REQUEST FOR ACTION (RFA)		
1. Review Type TKUP-A Demonstration Requirements Review	2. RFA No. 278-01	3. Review Date 8/2/06
4. Title Early validation of Shuttle functions

REQUEST FOR ACTION (RFA)			
1. Review Type TKUP-A Demonstration Requirements Review		2. RFA No. 278-03	3. Review Date 8/2/06
4. Title I:Q power ratio requirement

Figure 1. JEM-to-TDRS KaSA Return Link Configuration

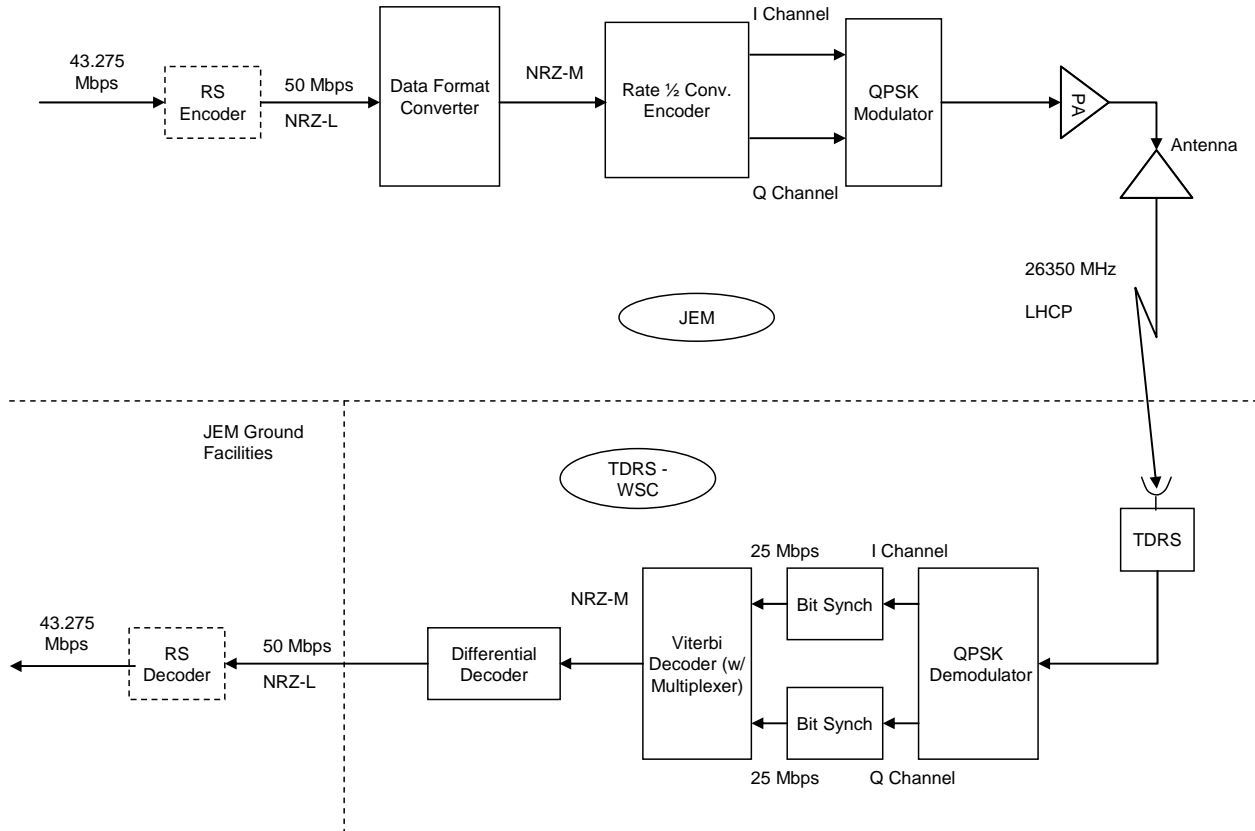
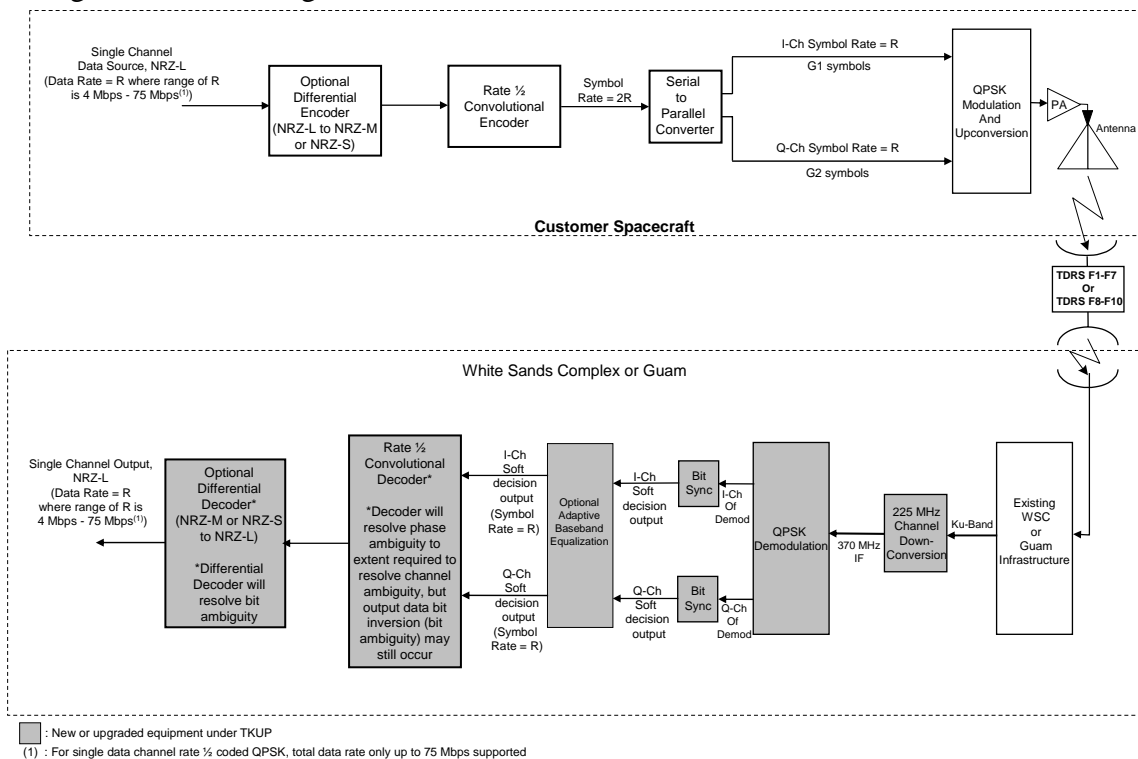
5. Action Ensure level 0 requirements include JEM requirements for single data channel QPSK. Does this requirement have an increased risk associated with channel ambiguity resolution to recombine single data channel requiring additional testing?			
Reference Slide 22-23

Section 4.2.2.2.b of the *Radio Frequency Interface Control Document Between the Japanese Experimental Module (JEM) and the Space Network (SN)* [1] indicates the JEM NRZ-M converts a 50 Mbps return service NRZ-L data stream, rate 1/2 convolutionally encodes it, and then alternates the encoded symbols onto the I and Q channel of a 1:1 QPSK modulator. The following figure illustrates these JEM return service operations:

The TKUP Requirements Specification (RS) includes support for the JEM return service configuration per the following sections and excerpts:

- Table 3-1: Rate 1/2 convolutional coding, single channel QPSK supported data rates: 4 Mbps – 75 Mbps. Same symbol rates on I-channel and Q-channel channel, but using alternate I/Q Encoded Symbols only. It is noted in Table 3-1 that the 75 Mbps maximum supported single channel data rate (i.e., total data rate = I+Q) was selected based upon the capability of commercially-available Viterbi decoder devices.
- Table 4-5, row c3 and note 4: Rate 1/2 Convolutional Coding, Single Channel at 4 Mbps - 75 Mbps. Single channel QPSK with same symbol rates on I-channel and Q-channel channel, but using alternate I/Q Encoded Symbols only. It is again noted in Table 4-5 that the 75 Mbps

Moving back to the original intent of the RFA, channel and bit ambiguity resolution for the single channel QPSK service mode are addressed in the following sections of the TKUP RS:

The TKUP RS does not state a required manner for resolving the channel ambiguity, however, it is expected that the implementation contractor will use the Viterbi decoder to resolve the ambiguity. Channel ambiguity resolution is possible with the Viterbi decoder as incorrect assignment of G1 to G2 symbols and G2 to G1 symbols by the Viterbi decoder will result in a continual inability to achieve or maintain decoder lock, assuming pattern data is not present. For additional discussion on this topic please consult the *ATV Bit Transition Density Requirement Justification* memo which is attached to this RFA response.

Note that channel ambiguity can be resolved with no feedback to the carrier tracking loop or bumping of the carrier tracking loop. Based upon the above envisioned channel ambiguity approach, it is felt that there is not sufficient risk to service mode to warrant inclusion in the TKUP-A demonstration.
